#### AIA HQ RENEWAL

COMMISSION OF FINE ARTS SHIPSTEAD-LUCE ACT DD REVIEW 2 JANUARY 19, 2023

#### **October DD Review Response Narrative**

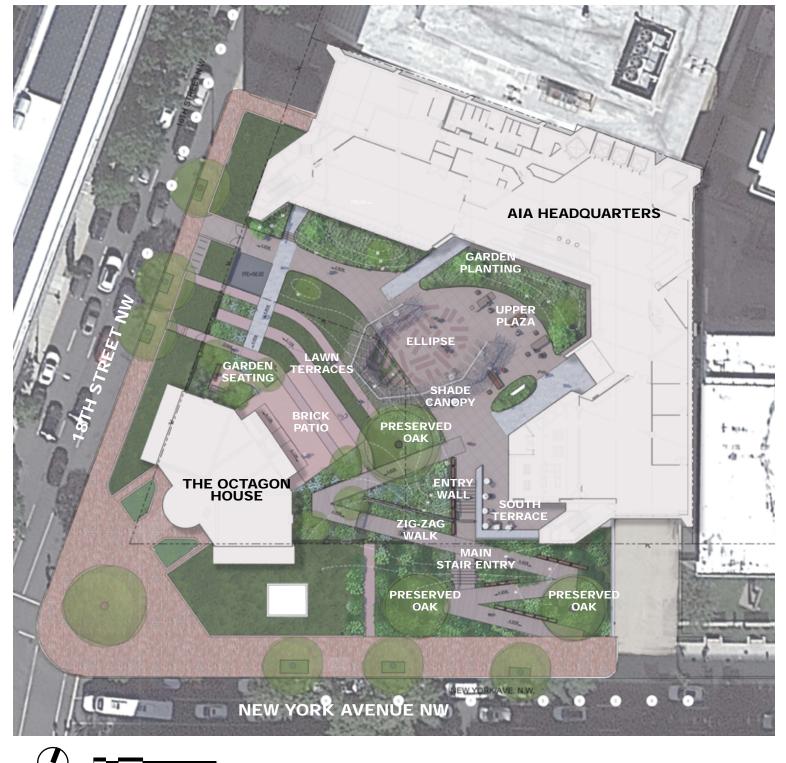
Additionally, minor architectural changes have been made with regard to the finish selections. We revised paint colors of the window system, sunshade and canopy structures. The frit pattern design has evolved as shown on the updated slide, but the concept from past presentations remains largely intact.

#### Site Plan Progress

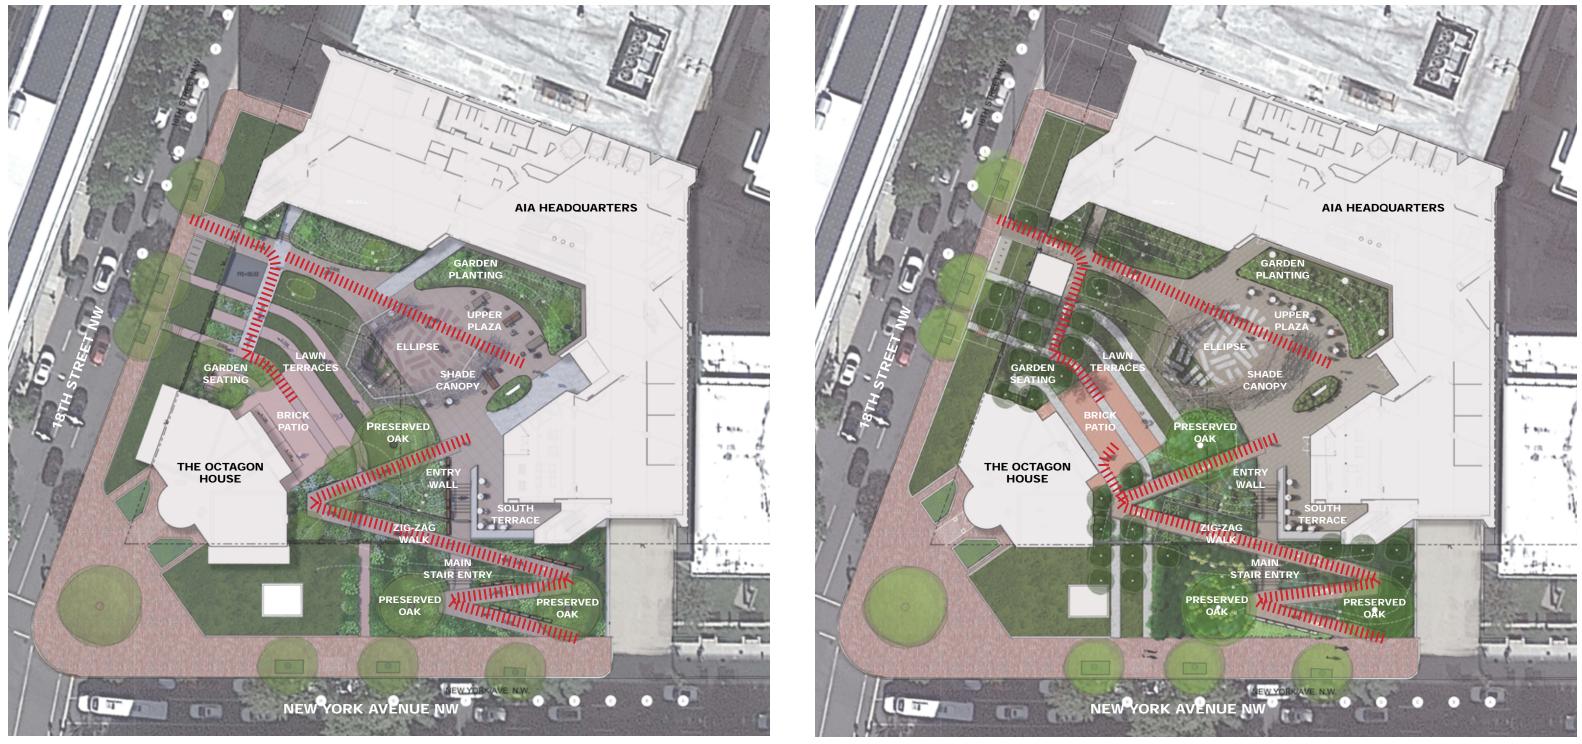
- Simplify secondary elements of the site including the fence, gates and railings so the main elements of the site (the boardwalk and trellis) can stand out.

- The supports of the trellis should be positioned to support the circulation routes through the site.

- The height and materiality of the fence should be re-evaluated to increase transparency into the site and make the entry feel more open.

- Reconsider the use of the red sandstone for the entry wall and other site elements.

Hood Design Studio has made the following adjustments to the design of the AIA headquarters. The kick-rail, handrail, fence and gates have been simplified to allow the featured elements of the site (the trellis and boardwalk) to be more primary to the site experience. The simplified gate and fence design also allows more transparency and visibility into the site creating a more welcoming experience while still providing the necessary security, utilizing thin square-tube pickets. The trellis columns have been realigned to allow for clear circulation routes. In keeping with the approach to allow key elements of the site to be prominent, all stone walls have been removed from the project, allowing the garden to cascade, uninterrupted, from the site to the city.
